**SOLICITATION AMENDMENT
MODIFICATION DE L'INVITATION**

Title - Sujet CCGS G. Peddle Drydocking	
Solicitation No. - N° de l'invitation F5561-220655/A	Amendment No. - N° modif. 002
Client Reference No. - N° de référence du client F5561-22-0655	Date 2022-12-02
GETS Reference No. - N° de référence de SEAG PW-SHAL-201-11601	
File No. - N° de dossier HAL-2-89075 (201)	CCC No./N° CCC - FMS No./N° VME
Solicitation Closes - L'invitation prend fin at - à 02:00 PM Atlantic Standard Time AST on - le 2022-12-13 Heure Normale de l'Atlantique HNA	
F.O.B. - F.A.B. Plant-Usine: <input type="checkbox"/> Destination: <input checked="" type="checkbox"/> Other-Autre: <input type="checkbox"/>	
Address Enquiries to: - Adresser toutes questions à: Crocker, Quentin	Buyer Id - Id de l'acheteur hal201
Telephone No. - N° de téléphone (902) 478-8034 ()	FAX No. - N° de FAX (902) 496-5016
Destination - of Goods, Services, and Construction: Destination - des biens, services et construction:

Solicitation amendment 002 is undertaken to:

HD-10 Refrigeration condenser cooling water line re-route and overboard valve installation

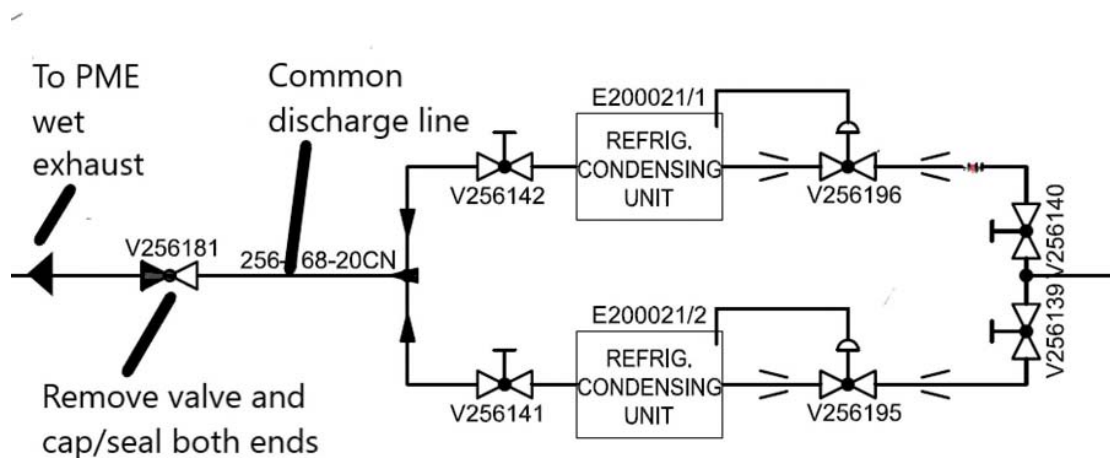
1. Install a new ABS approved overboard valve and thru hull penetration for the refrigeration condenser cooling water.
2. Cap off and terminate the old piping that leads to the existing port main engine wet exhaust line.
3. Re-pipe the refrigeration cooling water discharge line to the newly installed overboard valve.

1. Contractor must create a thru hull penetration and install the ABS approved Contractor supplied overboard valve as per drawing 22-109-524-01 Refrigeration Condenser System - OVBD SW Discharge Relocation Rev3. All labour materials used to complete this work must be contractor supplied other than the overboard valve.

4. The Contractor must supply and install **one** globe valve suitably placed in the pipe run to the overboard valve, preferably closer to the refer units. This valve will be a contractor supplied globe valve with nominal diameter the same as the piping below and have bronze disc, seat, stem and body. This valve will serve as an intermediate shut off valve. All labour and materials for this pipe run and capping must be supplied by the Contractor. Piping size and materials:
